STAFF RECOMMENDATION

1404 Linden Avenue

November 16, 2016

Application: Demolition; New construction – infill and outbuildings

SITE PLAN

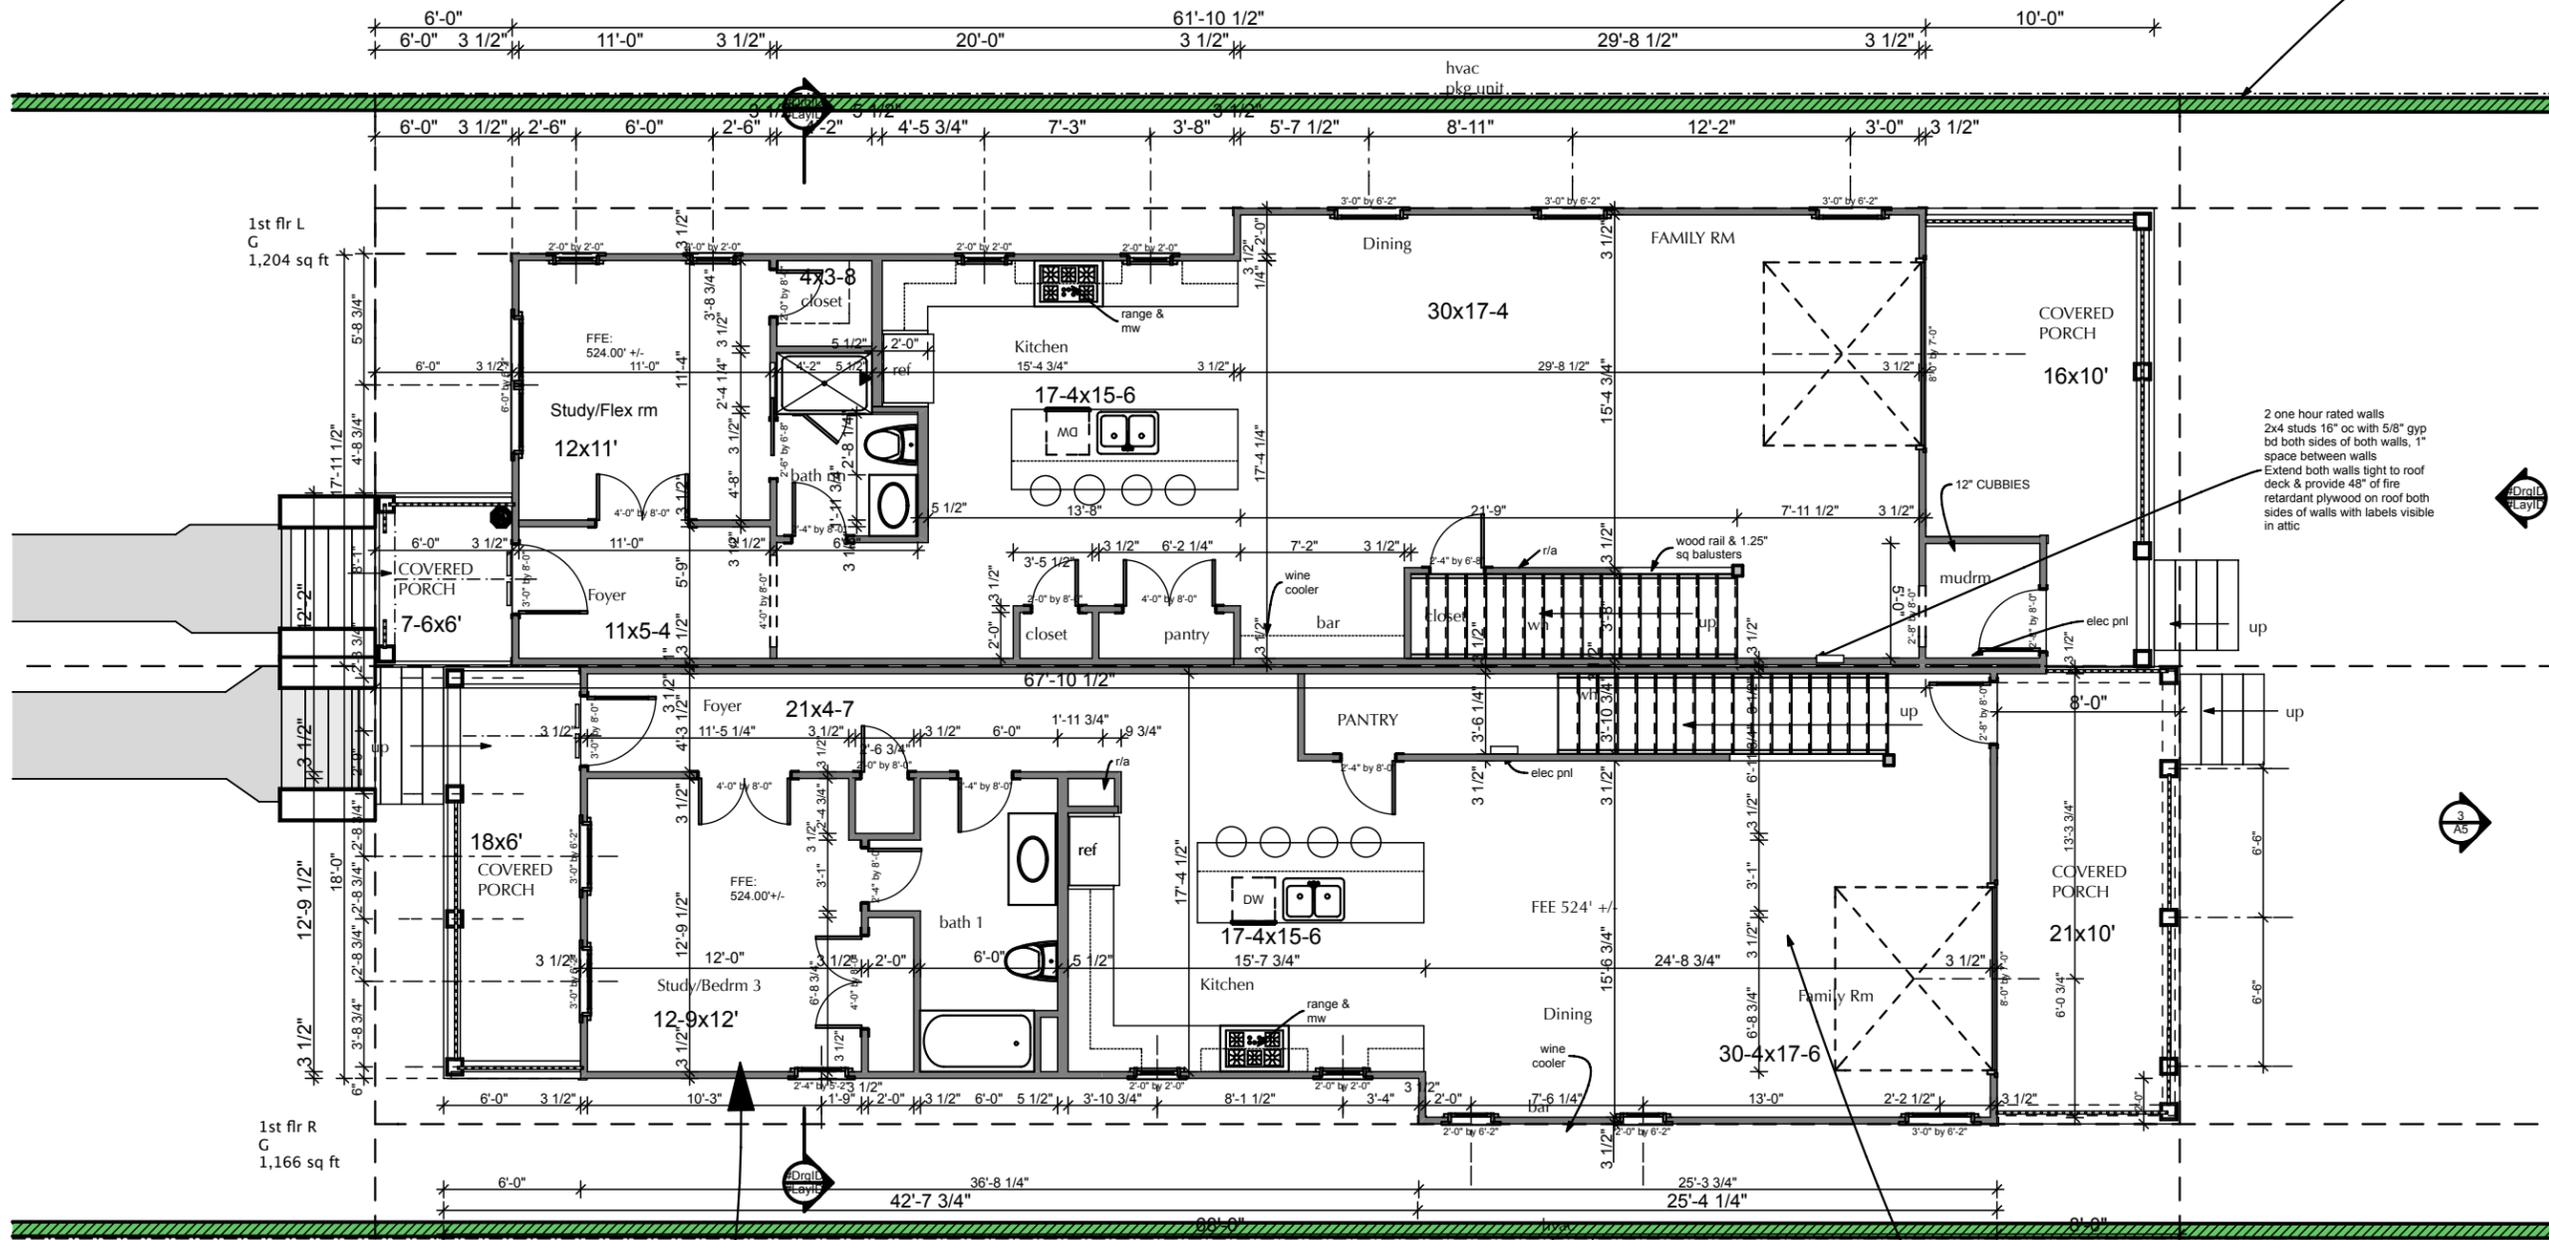
Appurtenances & Utilities: The infill will have two walkways leading from the sidewalk to the front porches, but there are no driveways or parking pads shown at the rear of the lot, despite there being two garages shown on the site plan. The location of the HVAC and other utilities was also not noted. Staff asks that the locations and materials of all paving shall be approved by Staff and that the HVAC would be located on the rear façade, or on a side façade beyond the midpoint of the house, to ensure that the project meets section II.B.1.h of the design guidelines.

SIDE ELEVATIONS

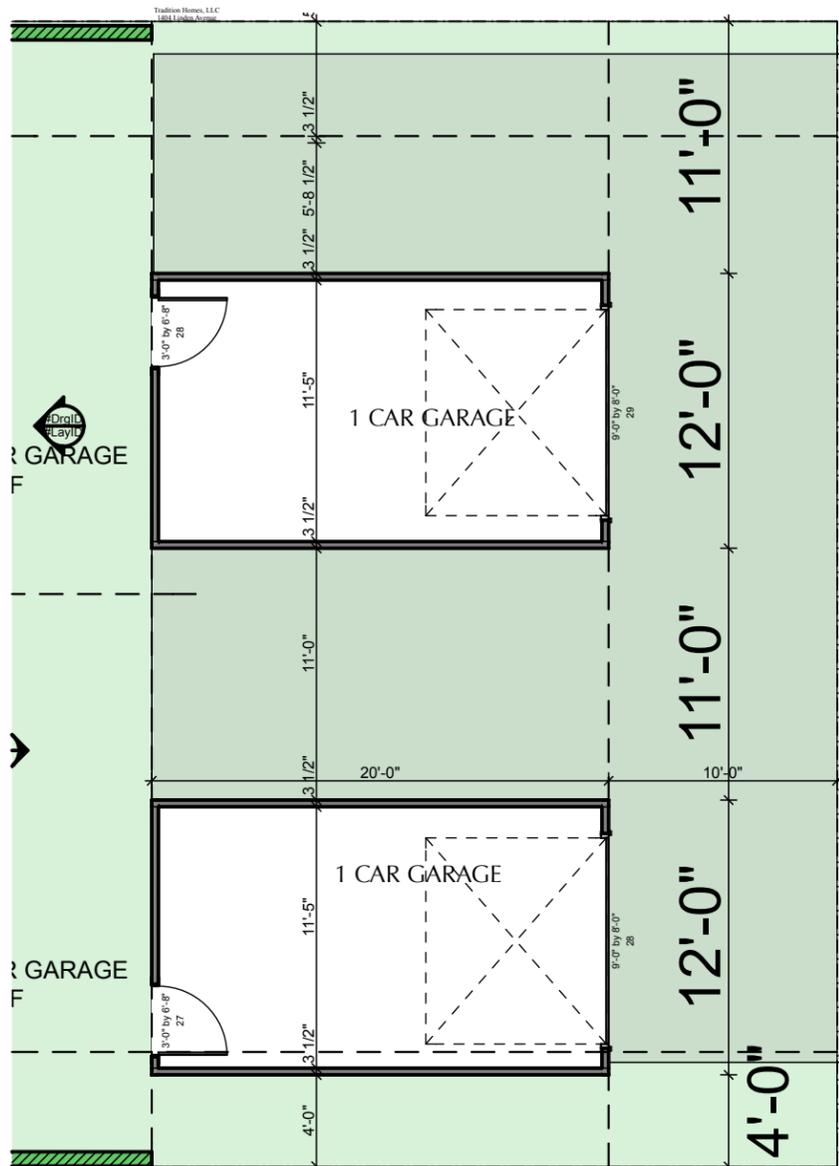
Proportion and Rhythm of Openings: Historic houses nearby typically have windows that are twice as tall as they are wide, with the first story windows larger than the upperstory windows. The windows on the proposed infill, with many small square windows and the upperstory windows larger than those of the first story, will not be compatible with the proportions of windows on historic houses. Staff finds the project's proportion and rhythm of openings will not meet section II.B.1.g of the design guidelines.

GARAGE PLANS

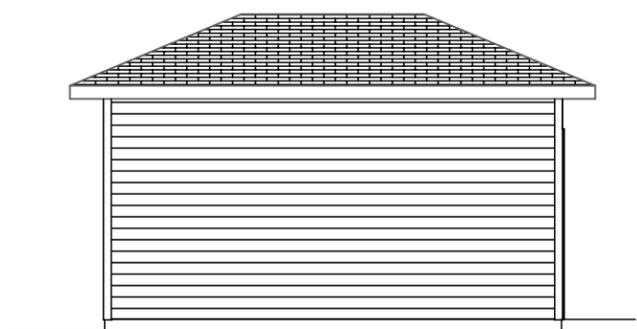
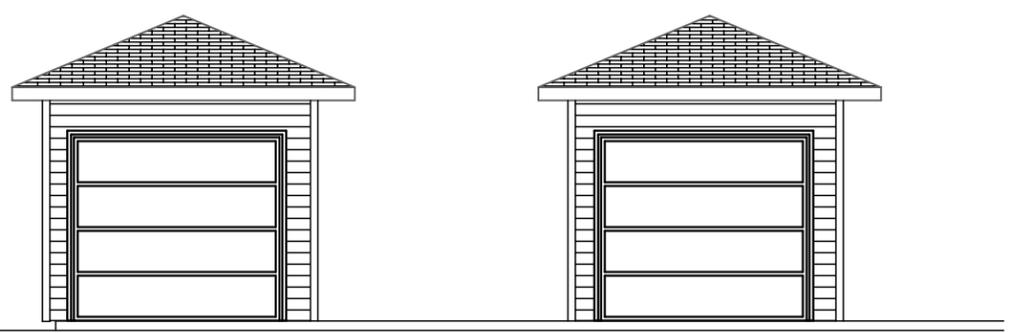
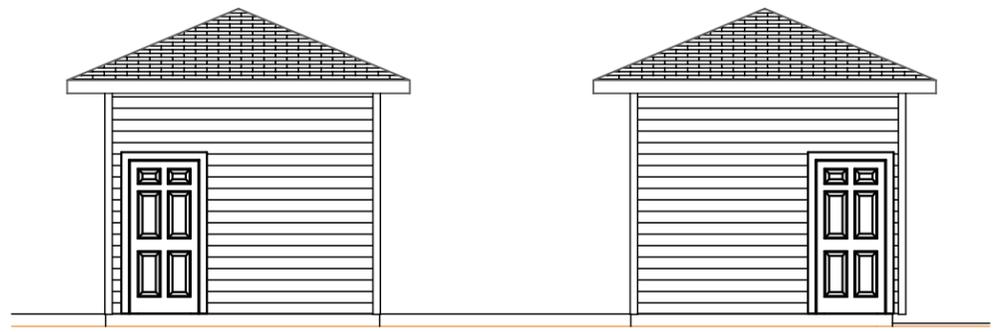
Outbuildings: The plan proposes two single-bay detached garages at the rear of the lot. They will be accessed via the alley, and each have a footprint of two hundred and forty square feet (240 sq. ft.) for a total of four hundred and eighty square feet (480 sq. ft.). The buildings will have hipped roofs, with ridge heights of fourteen feet (14') and eave heights of ten feet (10').

The proposed materials would match those of the principal building, including cement-fiberboard siding with a reveal of five inches (5”) and asphalt shingle roof and a concrete slab foundation. The garage doors will be metal. Staff asks to approve the final selection of door prior to construction. The outbuildings will not be used as Detached Accessory Dwelling Units. Staff finds that the proposed outbuildings would meet section II.B.1.i of the design guidelines.
